# Technical Service Bulletin

**Cobra Motorcycle Mfg.**

## TSB0804: 2004 King rear brake caliper carrier pad

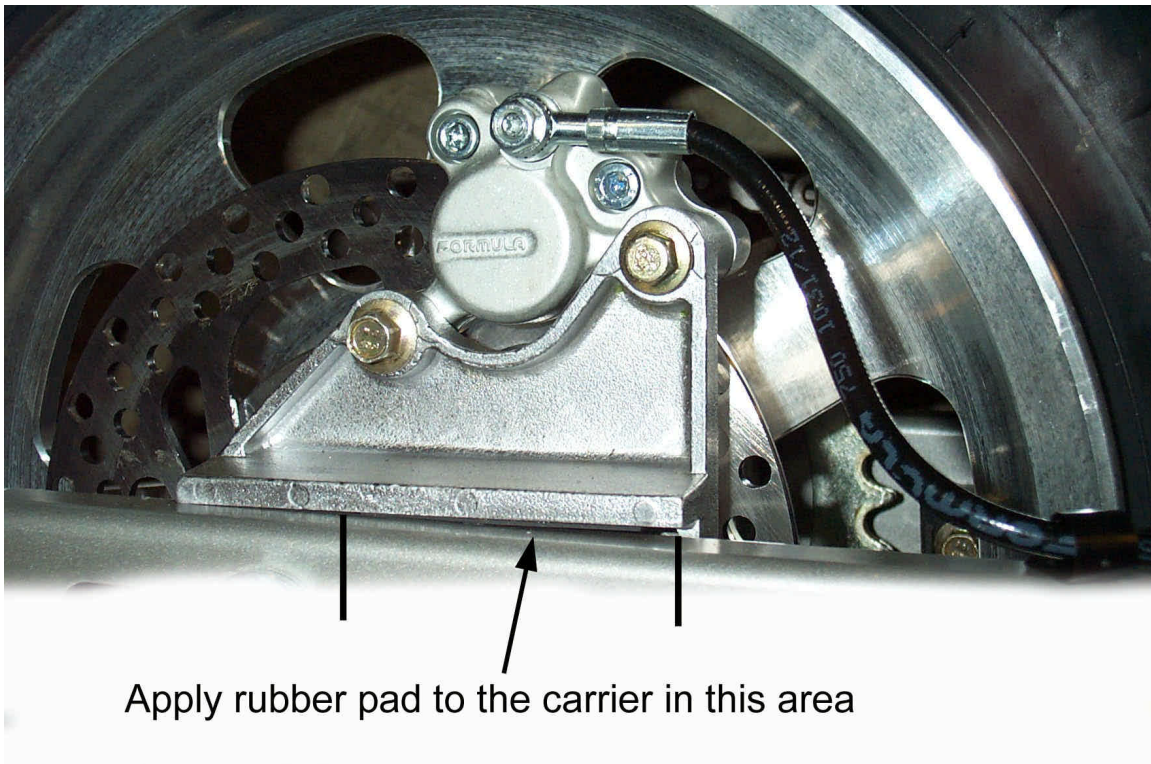
An adhesive backed rubber pad that acts as a cushion under the rear brake caliper carrier was absent from certain 2004 King models. The pads are available from Cobra and should be applied to the bottom surface of the brake carrier that mates against the top of the swingarm.

Apply rubber pad to the carrier in this area
